Comments and Responses Volume 6

CALAVERAS DAM REPLACEMENT PROJECT

San Francisco Planning Department File No. 2005.0161E
State Clearinghouse No. 2005102102

Figure 1. Demonstration of hydrologic variability at the USGS gage 11179000 (Niles Canyon)

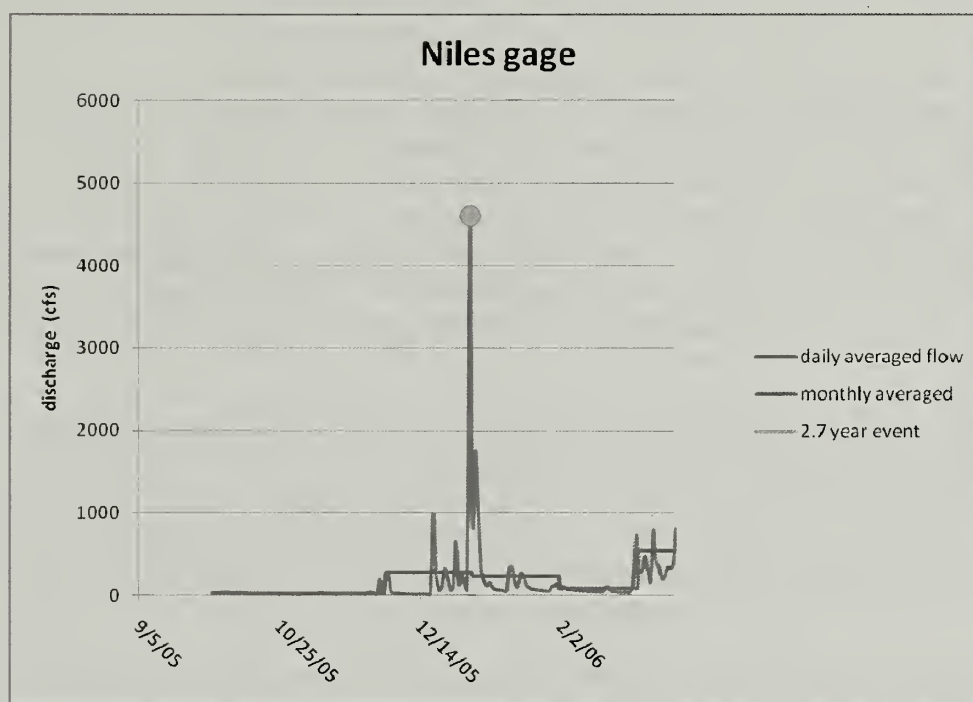
of the month. However, with the use of average monthly flows in the HH/LSM, the impacts of significantly reducing flows during a portion of the month would be obscured, or entirely overlooked in the DEIR impact analysis. Figure 1 demonstrates the typical annual variability that may be encountered in any given year, along with monthly averaged flow rates used for the HH/LSM analysis.

Figure 4. Water year 2001 hydrograph, and needed discharge for adult fish passage

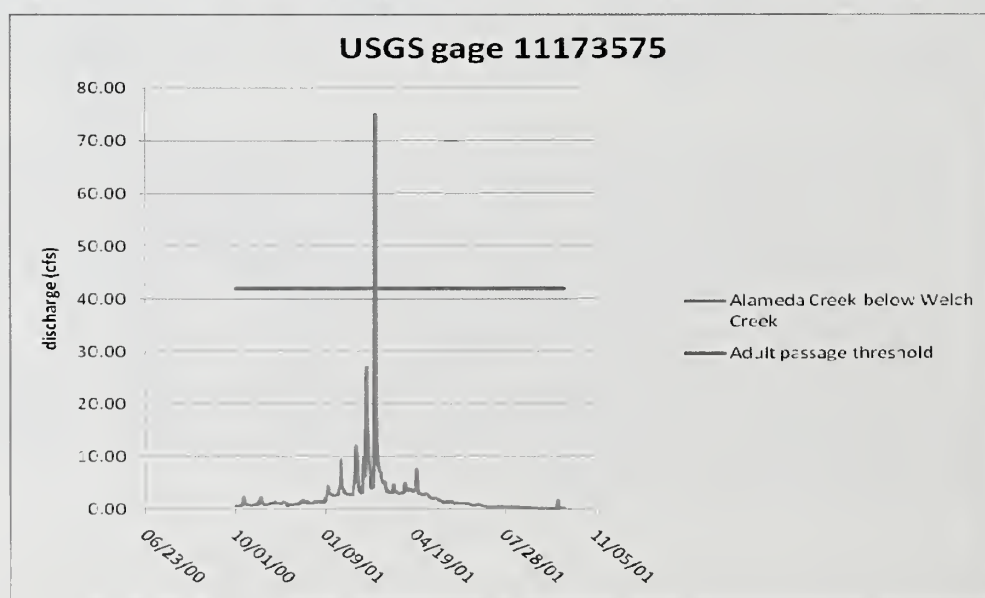
Rather than providing the needed flows for steelhead migration, the DEIR states that there will be sufficient opportunities for in-migration during high flow events, without providing additional releases to support the steelhead in-migration. However, as shown in Figure 4 below, an analyses of flow data at the USGS gaging station on Alameda Creek at Welch Creek, indicates that under pre-DSOD restrictions (Water Years 1999-2001) on average, adequate flows for steelhead in-migration occurred approximately 17% of the time during the in-migration season of December through March. In WY 2000 adequate flows were provided only 0.8% of the time, and WY 2001 provided adequate flows 32% of the time. Given that the DEIR acknowledges that the flow conditions under the CDRP would be similar to those which occurred under pre-DSOD conditions, it is clear that the DEIR fails to provide adequate commitments for the flows needed for steelhead in-migration. Similarly, adequate flows from the rearing habitat in the upper watershed downstream through Sunol Valley, Niles Canyon and Flood Control Channel must be provided such that smolts can out-migrate from the rearing habitat in the upper watershed to San Francisco Bay.

FIGURE 4.4.2: REGIONAL LAND COVER

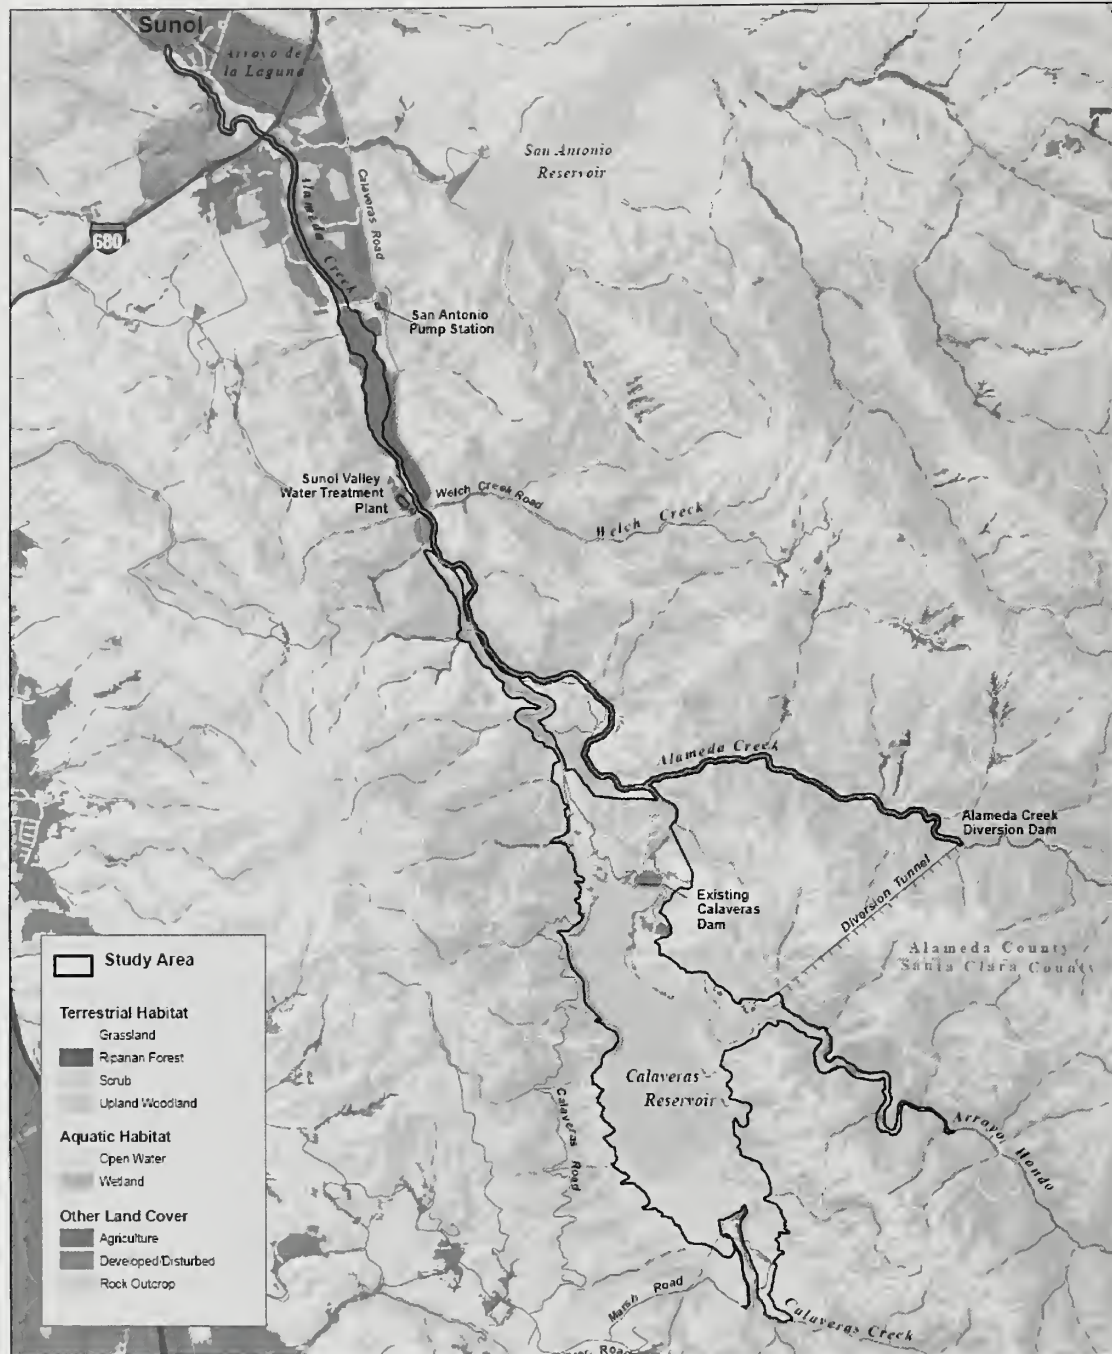
Figure 4.4.2 (Regional Land Cover) illustrates that this project may impact nearly all (~95%) of the Riparian Forest habitat downstream of the Sunol Valley Water Treatment Plant. CNPS believes this could be construed as equivalent to destroying the entire stream and its habitat. Yet, this impact was not clearly called out. CNPS believes partial impacts to streams may be possible to mitigate on site in a reasonable manner, but w not convinced that the impacts from inundation of this area are being taken seriously by the SFPUC. CNPS requests that the project and its impact areas be overlaid onto Figure 4.4.2 in order to provide a new figure to show impact location with relation to the entire study area.
